This submission comments on a range of issues across the PADR. For each issue we discuss what the proponents say and make comment. We then provide a number of questions that would form the basis of further engagement with AEMO and Transgrid. We would propose that these questions be combined with other questions that arise in submissions which would then be addressed at a combined engagement session (AEMO, Transgrid and consumer advocates) to ensure all stakeholders have the opportunity to be involved. In particular we would propose a deep dive with stakeholders on the key issue of the methodology used to justify the benefit stream starting 9 years before project completion – including starting some years before it is even approved by the AER.

<sup>7</sup> See p. 24 <https://www.transgrid.com.au/media/rxancvmx/transgrid-humelink-pacr.pdf>  
EUAA Submission: VNI WEST PADR | 09 September 2022

**Figure 1 Forecast NEM capacity to 2050, Step Change scenario**

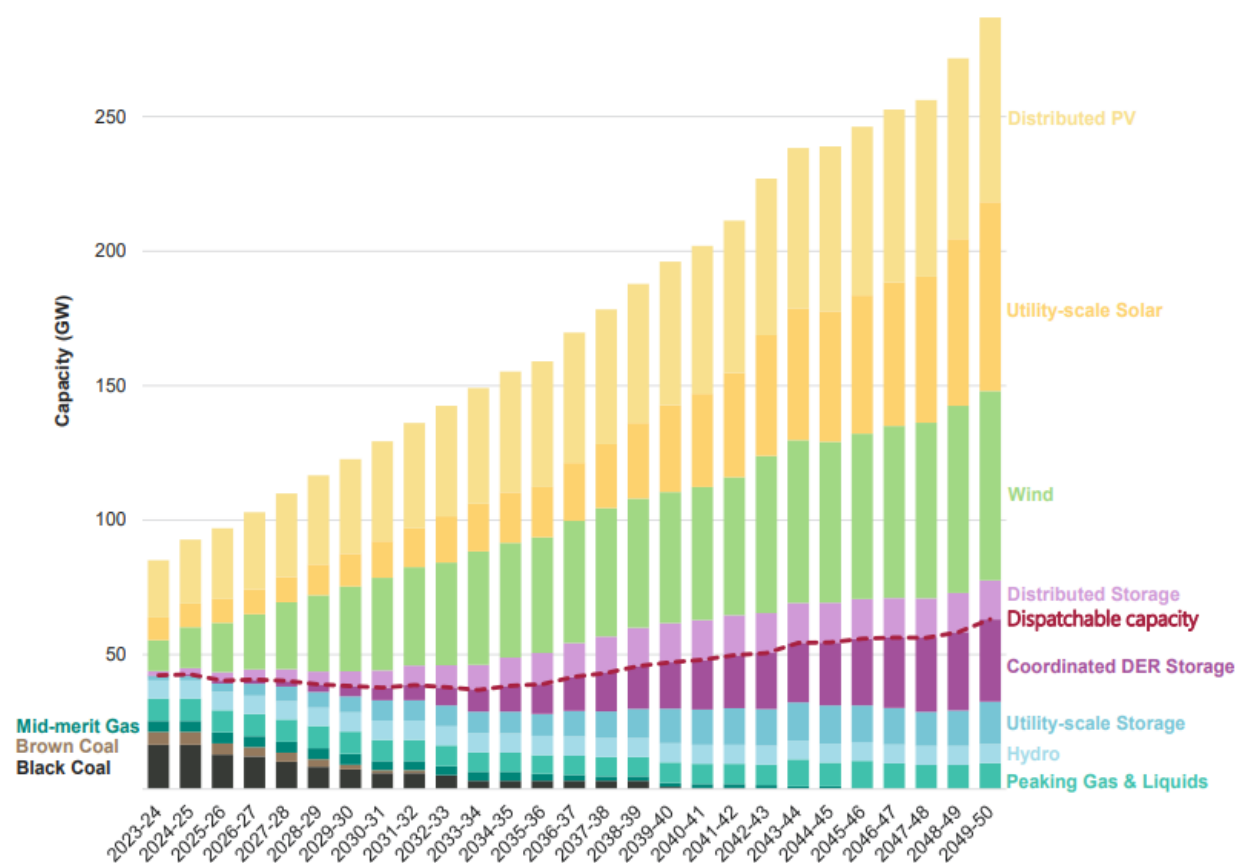
If we understand Figure 8 correctly then this ‘conservative’ assumption involves assuming that fuel cost savings from a reduced need for gas generation continue for the 50 year life of the project i.e. until 2072. The 2022 ISP forecasts minimal gas plant at that time<sup>16</sup>.

- What empirical evidence do the proponent have that their assumption is ‘conservative’?
- What are the assumptions on fuel cost savings beyond 2047-48? What gas cost is going to be avoided in 2050? 2055? 2060?
- Given that the life of generation assets that connect to VNI West is about a half to a third of the asset life of the transmission assets, what are the assumptions around stranded asset risks underpinning what is seen as a ‘conservative’ assumption that the undepreciated value of capital costs at the end of just ~16 years of actual operation?

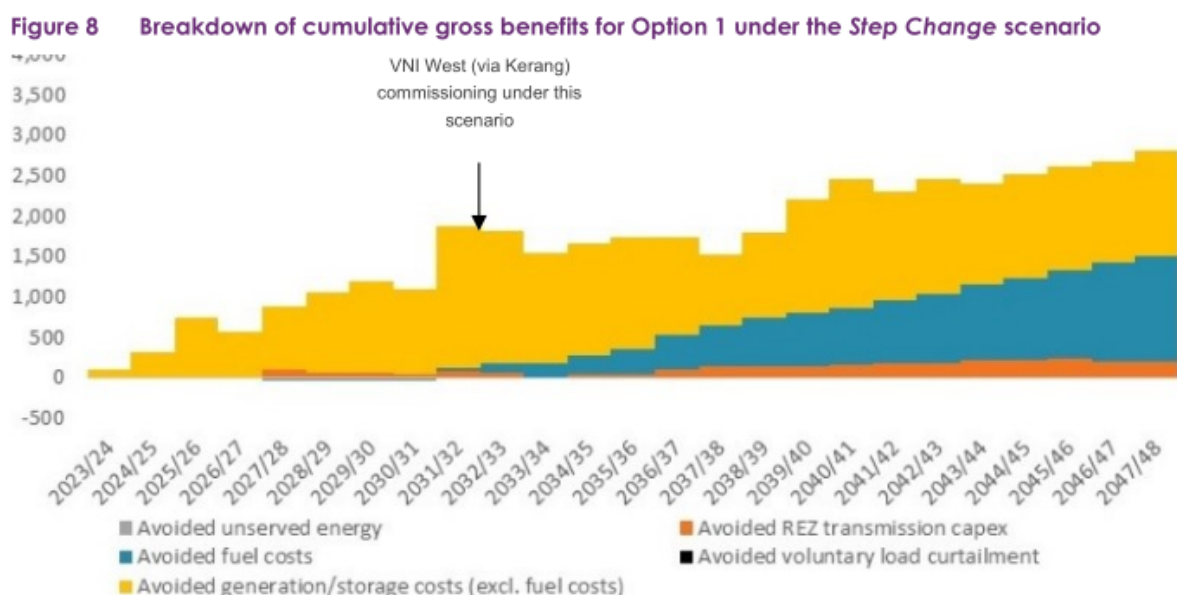
And now it seems AEMO is saying it wants to slow the transition down because it has significant benefits. This is the yellow part in Figure 8 for the step change scenario:

This table shows the significant benefits from delaying/avoided generation/storage costs that occur prior to commissioning in 2031-32 for the step change scenario start occurring in 2023-24. This is well before the project is expected to have even completed early works, let alone actually begin construction.
